Road Safety Audit Report

Incorporating
Stage 2 Completion of Detailed Design;
Design Organisation Response to items raised.

Proposed A350 Yarnbrook Road and West Ashton Relief Road, Trowbridge

Job no	RSA-20-043	Issue no	3	Date	August 2020
Prepared by	JJF	Verified by	FB	Approved by	JJF
Filename and Path	Fenley/Road Safety Audits/RSA-20/RSA-20-043-3

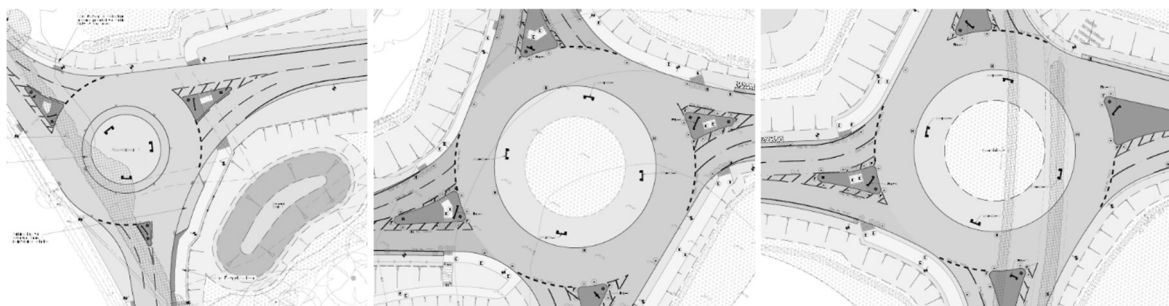
B.1	LOCAL ALIGNMENT
B.1.1	PROBLEM
Location:	Roundabout 1
Summary:	Drivers approaching the roundabout may not become aware of the junction at a safe distance
Acc Type:	Vehicle loss of control
The A363, Westbury Road is subject to a 40mph, and passes under a rail bridge. The scheme subject to this Stage 2 Road Safety Audit, includes the provision of the Yarnbrook and West Ashton Relief Road which commences from the west at a 3-arm roundabout just to the east of the rail bridge. A road safety concern raised within the previous Stage 1 Road Safety Audit (item 2.1) undertaken by others, identified a concern regarding the restricted level of forward visibility to the roundabout for eastbound drivers due to the bridge abutments and recommended the appropriate stopping sight distance and suitable advance warning signage is provided. The scheme drawings provided with the Audit Brief, illustrate that Advanced Directional Signage (ADS-1), as well as, an advanced 'SLOW' carriageway marking are to be provided to highlight the presence of the feature to encourage reduced speeds. However, insufficient forward visibility to the give-way line of the entry to the roundabout, could give rise to heavy braking, loss of control type incidents and junction overshoots.

RECOMMENDATION:	
It is recommended that an illuminated give-way road sign is provided either side of the southbound entry to enhance the conspicuity of the give-way	
Location Plan:   	
DESIGN ORGANISATION RESPONSE provided by PFA Consulting on the 14 th August 2020 following formal issue of this Stage 2 Road Safety Audit on the 23 rd July 2020	
Agreed. Give Way signs to be used. Proposed raised Keep Left sign on splitter island to be removed to avoid excess signage.	
B.2	GENERAL
B.2.1	PROBLEM
Location:	Scheme
Summary:	Insufficient space may be available for the expected vehicles
Acc Type:	Sideswipe type collisions

Location: Proposed A350 / Southern arm of Roundabout 2

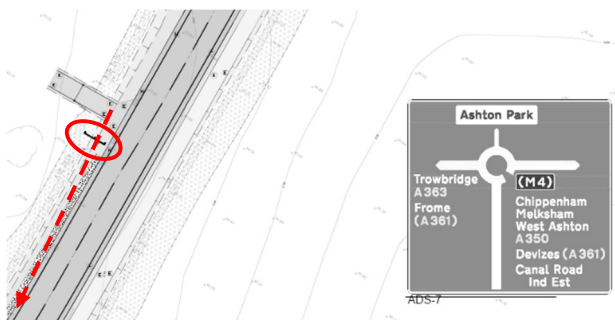
Summary: Proposed sign within the verge restricts visibility

The proposals associated with this Road Safety Audit realign the A350 to the east of Yarnbrook to meet the Yarnbrook West Ashton Relief Road at Roundabout 2. The realigned A350 accommodates a field access off the western side of the carriageway. No road safety concerns regarding the field access are raised at this stage, however, an Advanced Directional Signage (ADS-7) situated in the verge to the south of the access and mounted at 1500mm above the surrounding ground level, will restrict visibility to and from the field access. Restricted visibility to and from an access, could result in a vehicle attempting to exit when it is not safe to do so and increase the likelihood of a side or rear impact collision.

It is recommended that the appropriate visibility splays are maintained clear and free of obstructions.

Agreed. Sign either to be raised to 2.0m clearance and or repositioned on north side of junction.

Location: Roundabout 2 and Roundabout 3

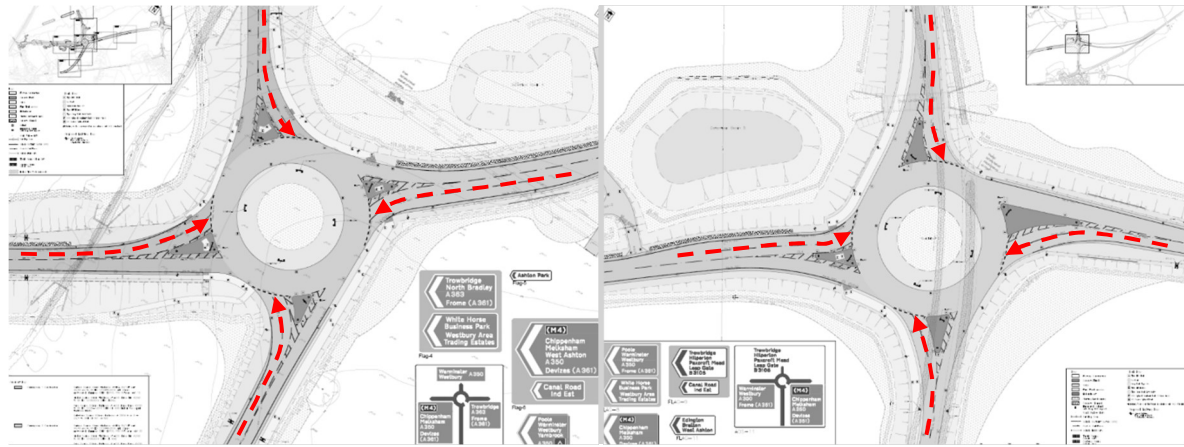
Summary: Frictional properties on approach to the roundabout may be insufficient

The proposals subject to this Stage 2 Road Safety Audit include the provision of the Yarnbrook and West Ashton Relief Road that includes a total of three roundabouts of which two accommodate 40mph/50mph approaches and the other 50mph/60mph approaches; two are on a steep down gradients, albeit at 1 in 40 on immediate approach. The scheme drawings identify that the proposed highway is to be surfaced with hot rolled asphalt (HRA) that benefits from a polished stone value (PSV) of 65. The information provided within the Audit Brief, identifies that the Relief Road is likely to observe a traffic flow in excess of 3000 vehicles during the peak hours which can be assumed to equate to a daily traffic flow of approximately 25,000. No details have been provided to identify the expected number of commercial vehicles, however, the more commercial vehicles that are observed, the more the surface deteriorates and experiences polishing, reducing the frictional properties. As such, a PSV of 65 on each approach to the proposed roundabouts may not be sufficient to assist heavy braking during the whole lifecycle of the surface, which could give rise to skidding and loss of control type incidents as well as overshoot type collisions.

It is recommended that the frictional properties of each approach are adequate and accord with Table 3.3 of CD236.

Agreed. The use of PSV 68+ is referenced in the pavement report. Therefore, note to be added to the drawings and Specification.

Location: Scheme

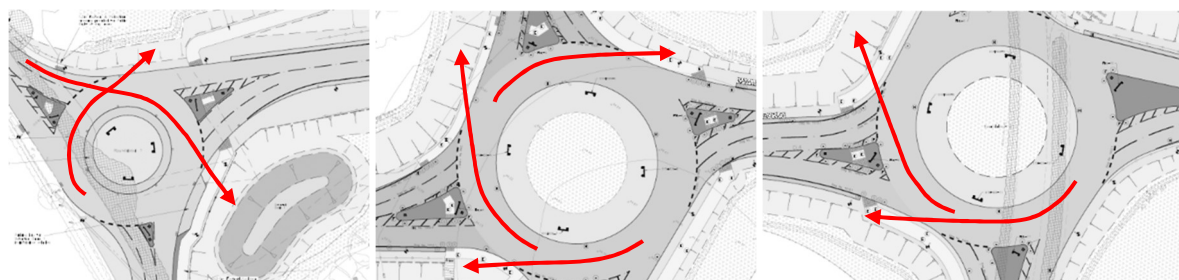
Summary: Errant vehicles could leave the carriageway down the adjacent embankments

The scheme associated with this Stage 2 Road Safety Audit includes the provision of a relief road that incorporates 3 roundabouts that lie at a level above the surrounding land and are subject to a speed limit above 40mph, as well as a number of detention basins for the sustainable drainage system. A post and rail fence is to be provided along the edge of the proposed verges and a vehicle restraint system is provided at certain locations, however, errant vehicles may be observed in proximity of the proposed roundabouts junctions where a VRS is not provided. The severity of an incident involving an errant vehicle leaving the carriageway is likely to be exacerbated by the presence of an embankment or detention basin, particularly following heavy rainfall.

It is recommended that a vehicle restraint system is provided in proximity to where errant vehicles could be observed

Agreed, subject to assessment including impact on other modes.

Location: Development access off Roundabout 2

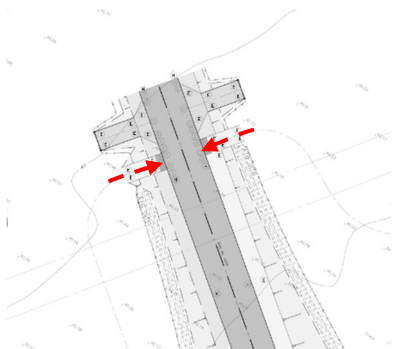
Summary: Users of wheeled devices could continue onto the carriageway suddenly

The scheme subject to this Stage 2 Road Safety Audit includes a development access road off the northern side of Roundabout 2 that is to be subject to a 30mph speed limit, as well as a network of pedestrian and cycle routes to include a 3 metre shared facility to the east of the development access. The shared facility terminates at a crossing facility that benefits from dropped kerbs and tactile paving where a link is provided into the land either side. The scheme drawings provided with the Audit Brief include a centreline identifying that the proposed links are to bend by 90° which would force users to slow, however, this is not confirmed. A user of a wheeled device such as a child on a scooter or cyclist approaching the crossing point may continue across the carriageway without slowing for approaching traffic raising the risk of vehicle user collisions or rear end impact collisions where an approaching driver brakes suddenly.

It is recommended that staggered barriers are provided to ensure users slow.

Agreed.

Location: Scheme

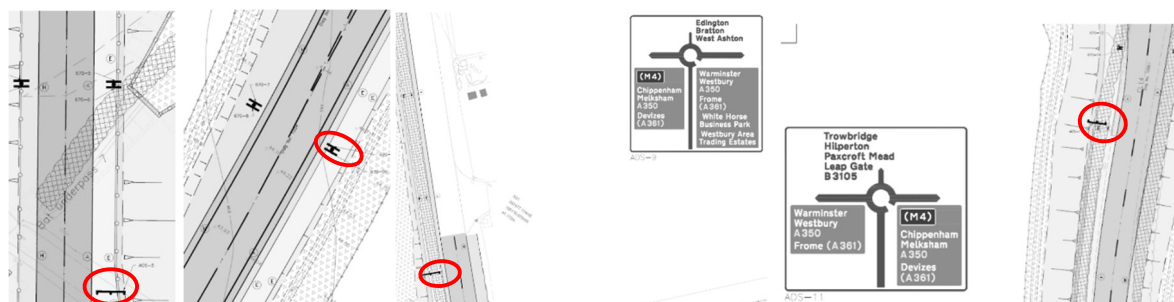
Summary: Signposts located within a footway cycleway will be an obstruction

The drawings provided with the Audit Brief, identify the location / design of signs and illustrates that the posts associated with a number of roundabout direction sign as well as back to back

speed limit signs that are to be situated within the centre of a proposed 3.0 metre shared footway / cycleway, albeit mounted at a height of 2.4-metres. A post within a footway / cycleway will be an obstruction particularly for the visually impaired and could result in a pedestrian or cyclist striking the item of street furniture.

It is recommended that signposts are located outside of non-motorised user facilities if possible or sufficient width is available between signposts and that measures are provided to highlight their presence.

Agreed. The aim will be to reduce number of posts in any footway to one which will have the additional of a white triangle on the ground each side of post.

Location: Scheme

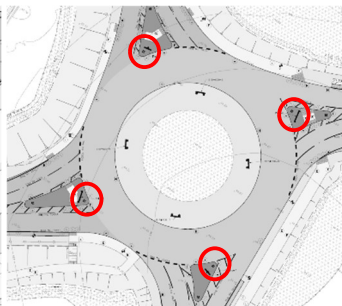
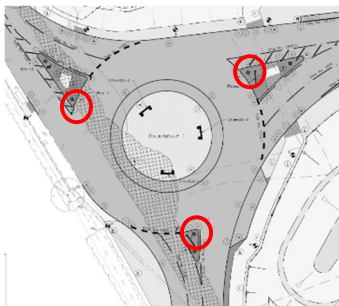
Summary: All proposed bollards accommodated on the splitter islands are 'Keep Left'

The proposals subject to this Stage 2 Road Safety Audit include the provision of the Yarnbrook and West Ashton Relief Road which accommodates a total of three roundabouts. The scheme drawings provided with the Audit Brief, identify that illuminated bollards are to be provided within the splitter islands to highlight the features, however, it appears that all bollards are to be provided with "Keep Left" arrows. The driver of a vehicle continuing around the circulatory of one of the roundabouts, may become confused and undertake a late manoeuvre to exit the roundabout and comply with the "Keep Left" requirement which could give rise to loss of control and sideswipe type collisions.

It is recommended that plain faced bollards are provided where applicable.

Agreed. Design to be amended.
